MODIFICATION PROPOSAL FORM

MODIFICATION PROPOSAL ORIGINATOR:	ESB GWM		
MODIFICATION PROPOSAL ORIGINATOR (CONTACT NAME)	Paul Doyle	MODIFICATION PROPOSAL ORIGINATOR FAX NUMBER:	
MODIFICATION PROPOSAL ORIGINATOR TELEPHONE NUMBER:	01-7027613	DATE:	24/10/14
MODIFICATION PROPOSAL ORIGINATOR E-MAIL ADDRESS:	Paul.doyle2@esb.ie	MODIFICATION PROPOSAL NUMBER (EIRGRID USE ONLY)	
GRID CODE SECTION(S) AFFECTED BY PROPOSAL:	CC.7.3.6.1 – Reactive Power Capability		
GRID CODE VERSION :	Version 5

MODIFICATION PROPOSAL DESCRIPTION

Proposed requirements are indicated by the solid line, the hashed line is used to display the difference between existing and proposed.

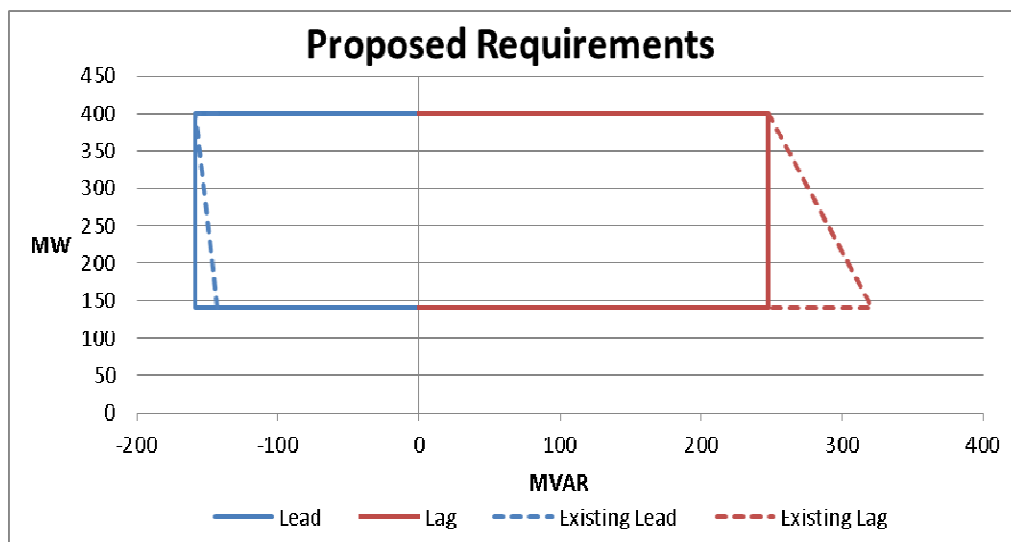
ESB GWM propose to change the reactive power requirements for conventional plant to have a single Mvar requirement in each direction (leading and lagging). The new requirement would be the same as the existing at registered capacity but now the requirement across all other active power output levels is represented by a straight vertical line down from the requirement at registered capacity. This would result in a reactive power requirement as shown in the “Proposed Requirements” chart.

ESB GWM propose this modification for the following reasons:

- 1. The additional lagging reactive power currently required at lower active power outputs cannot be used by the TSO as only a single reactive power declaration can be entered in each Leading and Lagging direction. This misalignment between the Grid Code and the market has been highlighted on numerous occasions by industry. Most recently it was highlighted as part of the DS3 product definitions where both the TSO and the RA's stated that they only want the market to remunerate reactive power which is available across the full active power range i.e. they do not want to facilitate multiple reactive power capabilities depending on active power output. This misalignment between Grid Code and market systems has in the past caused units, whilst being fully compliant, to incur GPI's for reactive power based on the single declaration limit in EDIL.**

- 2. This additional reactive power capability places additional costs on conventional generators including:**
 - a. Increased size and tapping range for Grid transformers**

- b. Increased generator costs due to higher than standard IEC generator voltages**
 - c. Additional switchgear costs due to increased voltage withstand requirements**

- d. Increased tapping range for house transformers**
- 3. To align the reactive power requirements for conventional generators with the requirements for both WFPS and Interconnectors. Both of these technologies currently have requirements in line with what is proposed.**

- 4. The modification actually provides the TSO with more leading reactive power from units at low load i.e. a greater technical capability. This is particularly important when attempting to control high voltages on a lightly loaded transmission system.**

CC.7.3.6 Reactive Power capability

CC.7.3.6.1 Each Generation Unit shall have the following Reactive Power capability as measured at their alternator terminals:

Voltage Range	Connected at:	At Registered Capacity between:	At 35% of Registered Capacity between At all other outputs:
99kV ≤ V ≤ 123kV	110kV	0.93 power factor leading to 0.85 power factor lagging	0.7 power factor leading to 0.4 power factor lagging A straight vertical line from the requirement at Registered Capacity
85kV ≤ V < 99kV	110kV	Unity power factor to 0.85 power factor lagging	0.7 power factor leading to 0.4 power factor lagging A straight vertical line from the requirement at Registered Capacity
200kV ≤ V ≤ 245kV	220kV	0.93 power factor leading to 0.85 power factor lagging	0.7 power factor leading to 0.4 power factor lagging A straight vertical line from the requirement at Registered Capacity
190kV ≤ V < 200kV	220kV	Unity power factor to 0.85 power factor lagging	0.7 power factor leading to 0.4 power factor lagging A straight vertical line from the requirement at Registered Capacity

360kV ≤ V ≤ 420kV	400kV	0.93 power factor leading to 0.85 power factor lagging	0.7 power factor leading to 0.4 power factor lagging A straight vertical line from the requirement at Registered Capacity
350kV ≤ V < 360kV	400kV	Unity power factor to 0.85 power factor lagging	0.7 power factor leading to 0.4 power factor lagging A straight vertical line from the requirement at Registered Capacity
